December 19, 1984

Subject: Three Mile Island Nuclear Station, Unit 2
 Operating License No. DPR-73
 Docket No. 50-320
 Technical Specification Change Requests 39, 41, 43
 Recovery Operations Plan Change Requests 19, 20, 22
 Exemption Request from 10 CFR 50.55a (Code Safety Valves)
 Exemption Request from 10 CFR 100, Appendix A and
 10 CFR 50.36(3) (Seismic Instrumentation)

Enclosure 1

5.4 REACTOR COOLANT SYSTEM

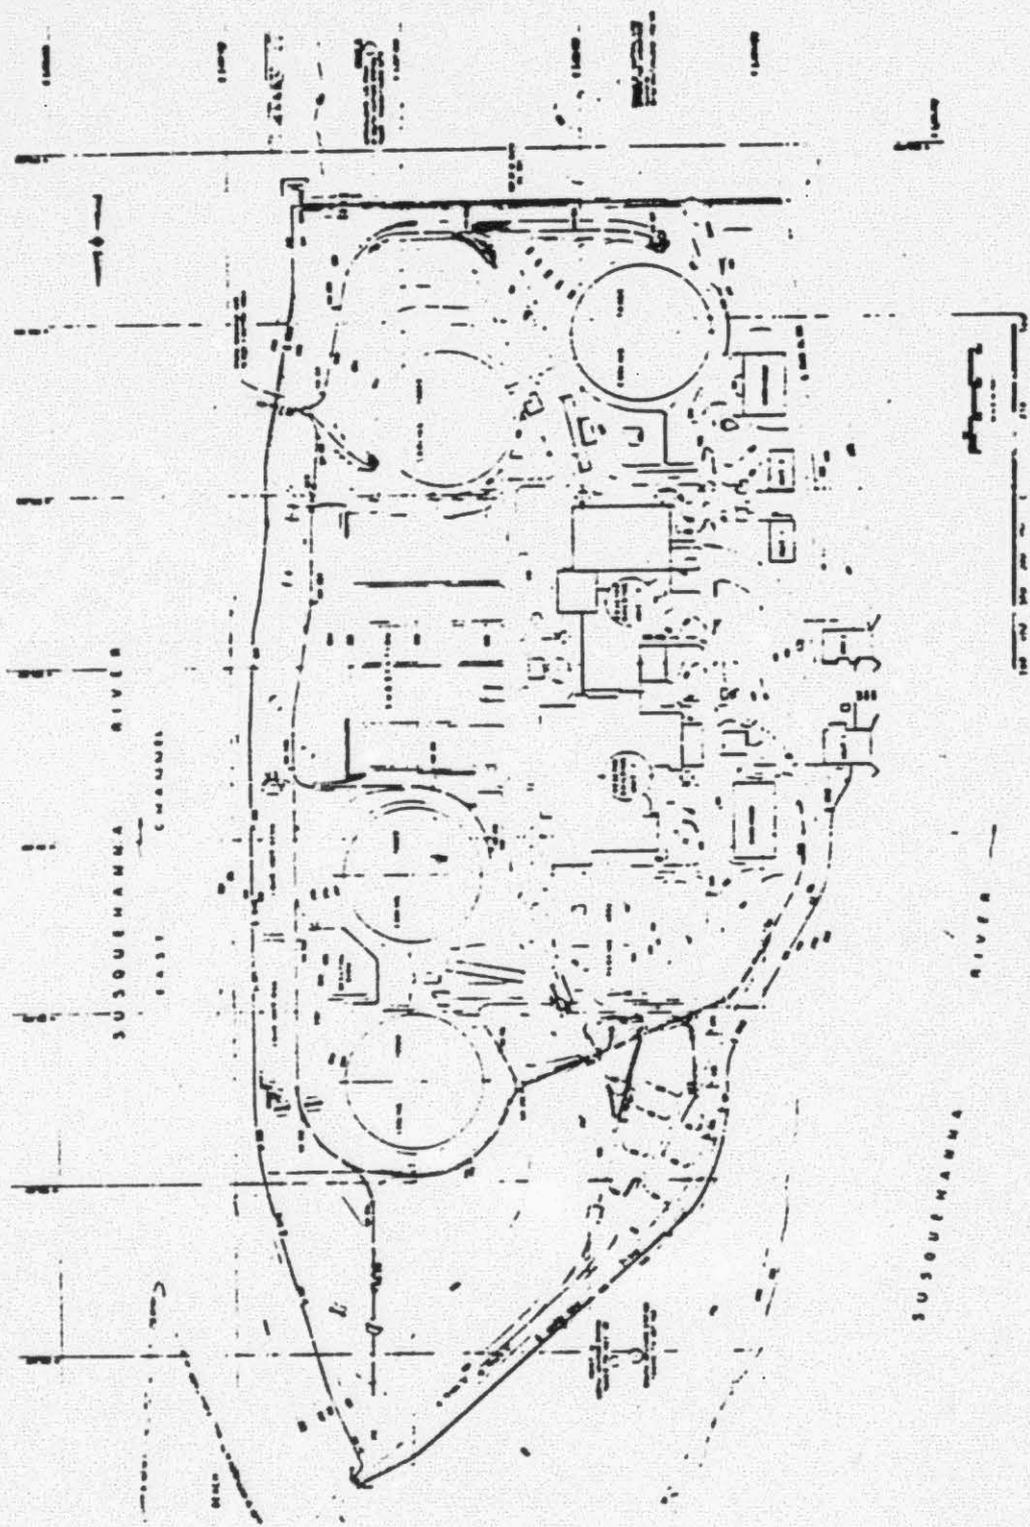
Section 5.4.1 - Reactor Coolant System Design Pressure and Temperature - This change was initiated by the NRC and discussed and agreed upon by the licensee. When considering the transients that occurred during the accident

and the minimum preventative maintenance that has been performed on the RCS, it is not possible to state exact design features. Also, there are no credible transients that could drastically change the existing RCS pressure and temperature. Therefore, a design basis pressure and temperature is not required for TMI at this time. Should the status of the RCS change, the staff will re-evaluate its position on this matter.

5.4.1 Deleted
